Technical Service Bulletin

SUBJECT: **Installation of condensation shield**

AFFECTED UNITS: **GPS-iMOD® UNITS**

Figure 1
(side view of shield)

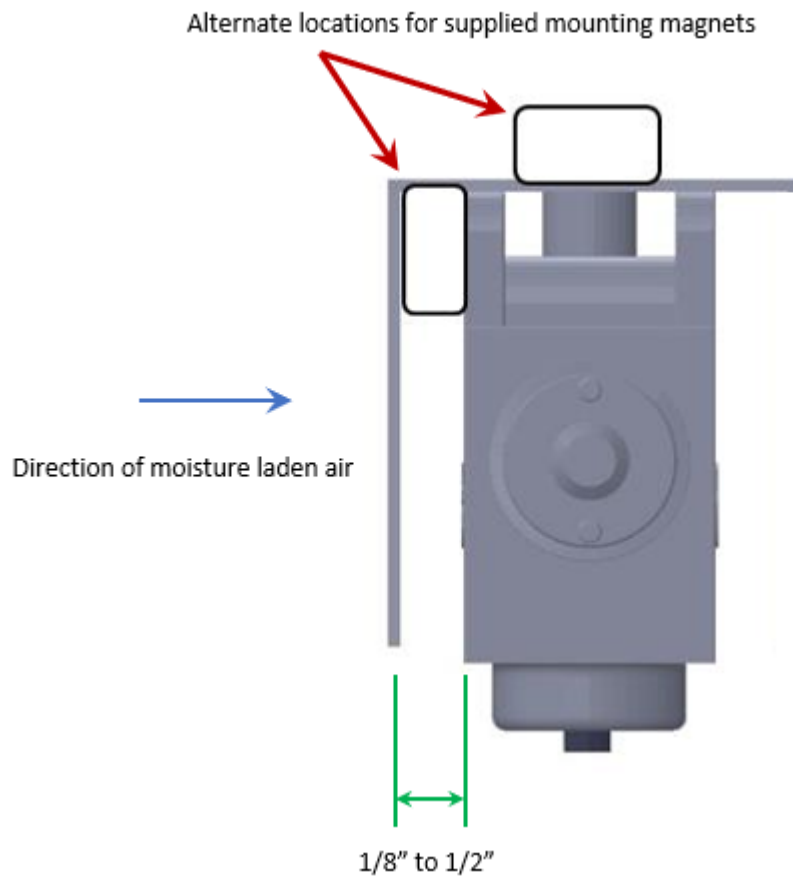
DESCRIPTION: In instances when GPS-iMOD is installed near humidifiers or downstream of cooling coils, condensation may form on the ionization bars.

The above conditions can result in lower than expected ion densities downstream from the GPS-iMOD bar.

Installation of a condensation shield over the modular iMOD ionization bars.

1. Select a suitable conductive material such as galvanized sheet metal for the shield.
2. The sheet metal should run the length of the GPS-iMOD ionizer bar and cover the upstream wall of the bar.
3. The sheet metal should not extend below the body of the ionizer, ensuring that the emitter tips have direct exposure to the airstream.
4. The shield should be secured using self-tapping sheet metal screws (**taking care not to puncture or otherwise damage refrigerant lines, coils, or electrical components**), or by using sufficient magnets fastened through to the GPS-iMOD ionizer bar to support the assembly.
5. The GPS-iMOD should not be touching the shield or the coil

- The iMOD power supply should be de-energized (turned off) during installation.
- Ensure that the shield bracket is grounded to the GPS-iMOD power supply.
- The clearance between the GPS-iMOD bar wall and the bracket should be no smaller than 1/8" and no larger than 1/2".
